ADDENDUM NO. 1

SUBJECT: Addendum No. 1 – Old Broadway Sidewalk Improvements

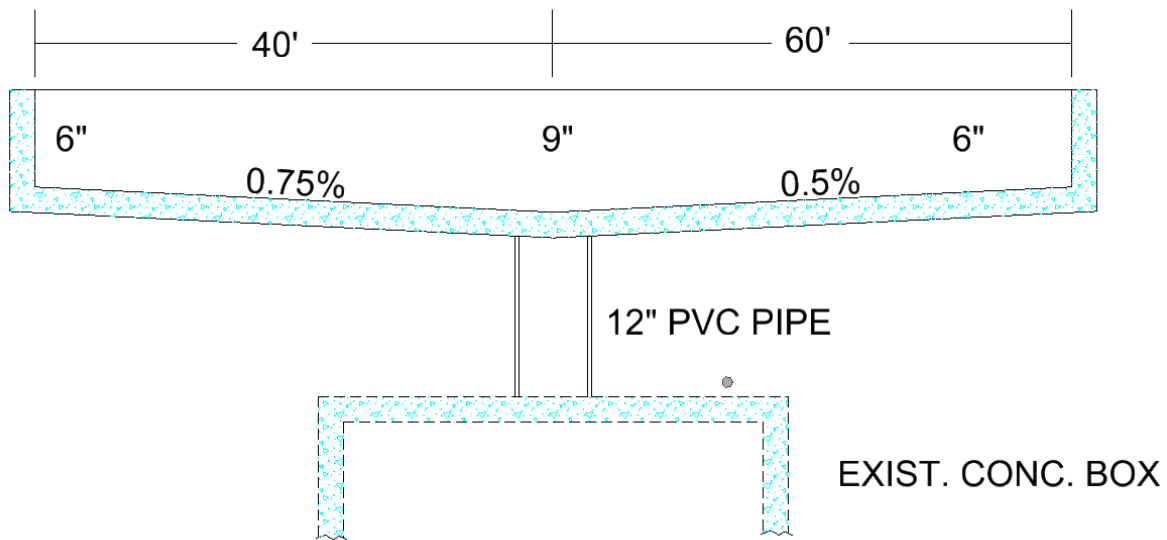
Question #9: How is the trench drain to connect to the box culvert? How is the connecting pipe paid for?

Response: Per TDOT Std Dwg D-TD-1, note 14 all materials are included in the unit price of the item.

The proposed design is that drains on either side of the culvert flow towards the low point over the culvert. A precast trench drain is acceptable for this application. Below is a general sketch.
